LINCOLN COUNTY HEALTH DEPARTMENT
ENVIRONMENTAL HEALTH
AFFIDAVIT OF WASTEWATER TREATMENT AND DISPOSAL SYSTEM COMPLIANCE REVIEW FOR SYSTEM INSTALLED, REPAIRED OR REPLACED WITHOUT A VALID PERMIT

Property Owner: Gateway Freedom Ranch c/o Buck Schermerhorn

Address or Location: 111 Glen Lake Dr, Eureka, MT 59917

GATEWAY FREEDOM RANCH SITE LAYOUT

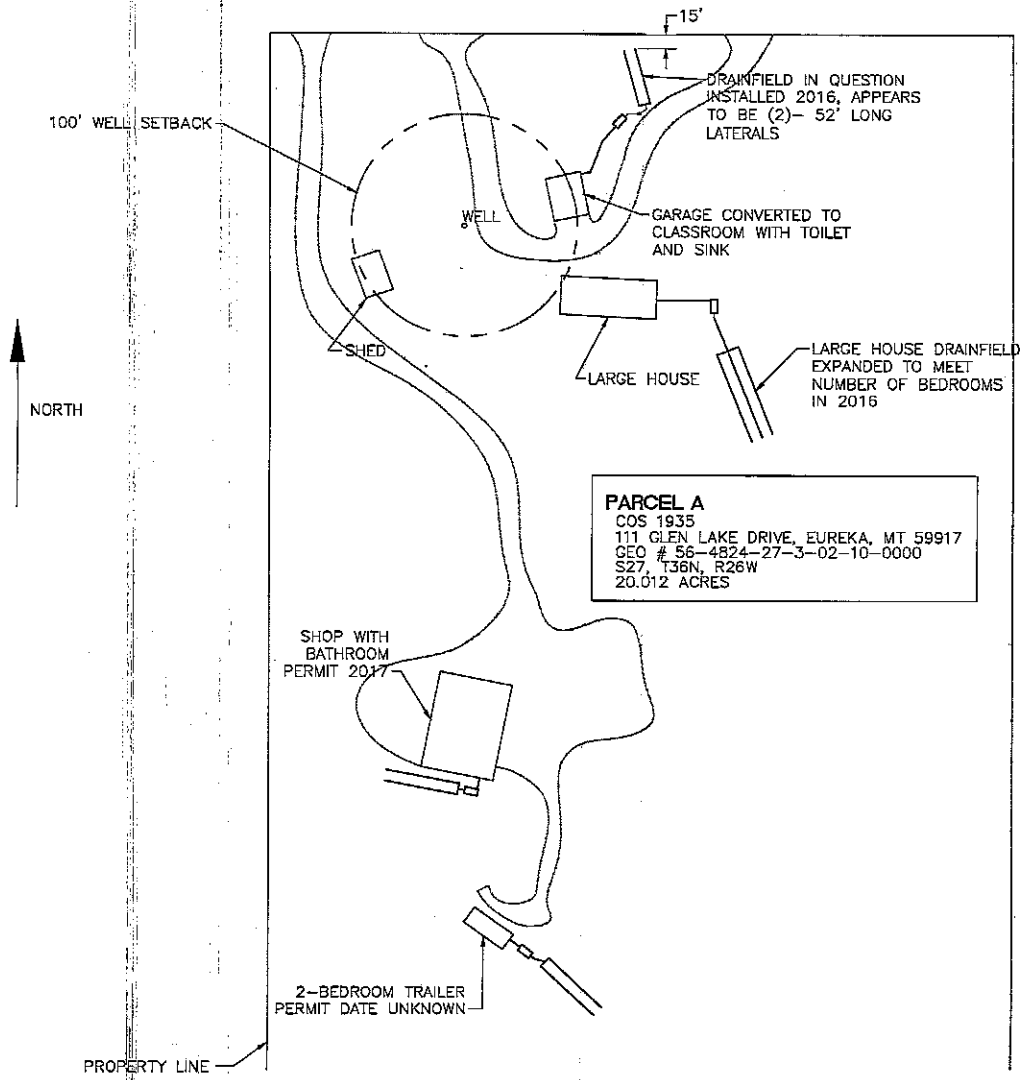
Comments: Gravity system using 1000 gallon tank and 2' wide infiltrator galleries in gravelless trenches. System components (including tank, d-box, and drainfield) were inspected by Montana Design Services on 6/22/22 and 6/24/22 and reported to be in working order. System is appropriately sized for wastewater flows of 110 gallons per day. Any future extension, repair, replacement or increase in wastewater flows must be reviewed and permitted by Lincoln County Health Department.
